Cumberland County Review Report

Name of Amendment:				
Middlesex Township New Zoning Ordinance and Zoning Map				
Municipality:	Date Received:	Date Reviewed:	Reviewed By:	Checked By:
Middlesex Township	3/21/2025	4/17/2025	SH, EG, KS	Planning Commission
Type of Amendment:				
New Zoning Ordinance

Middlesex Township has submitted a new zoning ordinance and zoning map for review and comment. The proposed zoning ordinance will replace the existing Middlesex Township Zoning Ordinance that was adopted in 1989.

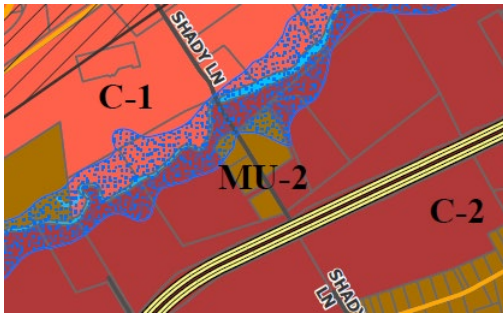
1. The township has received a number of map amendment requests to the proposed zoning map as well as formal zoning map amendment submissions to rezone parcels under the current zoning ordinance to Village Center, which is not a zoning district under the proposed zoning ordinance. The township should consider closing additional amendment submissions until such time as the zoning ordinance is approved to avoid confusion and promote transparency to the public which has access to the proposed draft ordinance and map on the township website. Applicant requested map amendments could be addressed as public comments on the zoning ordinance.
2. The area north of Ridge Drive should be zoned agriculture as single family detached dwellings are permitted on the same lot size as the R1 district (see below).

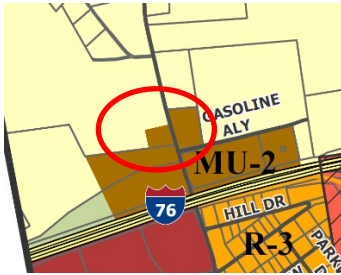
3. The need for the area zoned MU2 between the Pennsylvania Turnpike and Interstate 81 should be evaluated. The properties are existing residential units in a remote location of the township with limited highway access. These properties are not consistent with the MU-2 purpose statement in the zoning ordinance. The township should consider making this area C2 (see below) to better fit with surrounding zoning and commercial land uses (kennel).

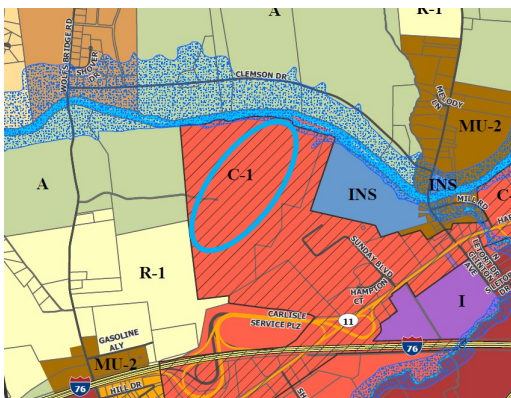
5. The township is proposing to change the following parcel from residential farm (RF) in the existing ordinance to commercial highway (C-1) and the redevelopment opportunity (ROO) overlay in the new zoning ordinance (see circled area below).

The area has limited accessibility to the Harrisburg Pike and therefore does not offer the development potential that other parcels in the proposed corridor provide. In addition, the area includes undeveloped land that is rural in character next to the Conodoguinet Creek.

One of the stated purposes of the ROO is to encourage reinvestment, revitalization and overall enhancement of the Miracle Mile corridor via infill, replacement and redevelopment opportunities on previously developed or underutilized land by providing greater flexibility. The defined area for the overlay district extends well beyond the immediate Harrisburg Pike corridor into areas that are not already developed. This contradicts the purpose of the overlay district.
